SERVICE BULLETIN

RADCO SALES LTD. - TECHNICAL SERVICE

Affected Models: DAY-TIME CHARGING PROBLEMS

Bulletin No.: 135

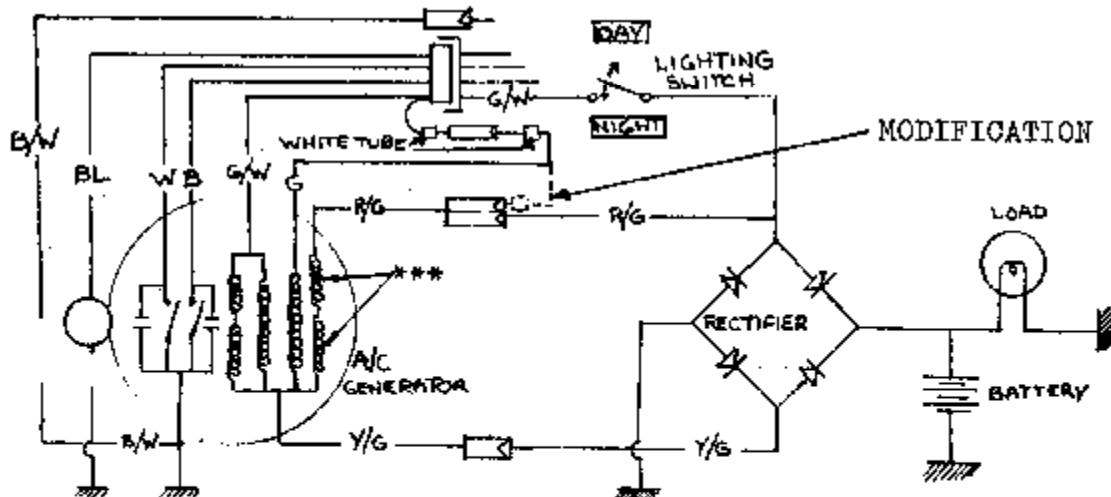
The wiring diagram below is that of the AC generator assemblies under the part numbers 31400-18520 and 31400-18521.

As the diagram shows, the generator charges the battery with two coils connected in series when the ignition switch is in the day-time position. The two appropriate coils are marked (****) on the diagram.

The charging capacity of the machine can be increased when the ignition switch is in the daytime position by disconnecting the white and green wires (These are connected on the diagram in the area where you see the words 'white tube') and connecting the removed male end of the green wire to the female coupler on the red/green wire.

As you can see, the charging rate in the night-time position remains unaffected as the extra coil brought into play by this modification is still utilized during night time riding.

This modification should only be performed when the customer complains of insufficient charging when riding during the day, and the rectifier and wiring and all component electrical ground circuits are in good condition.
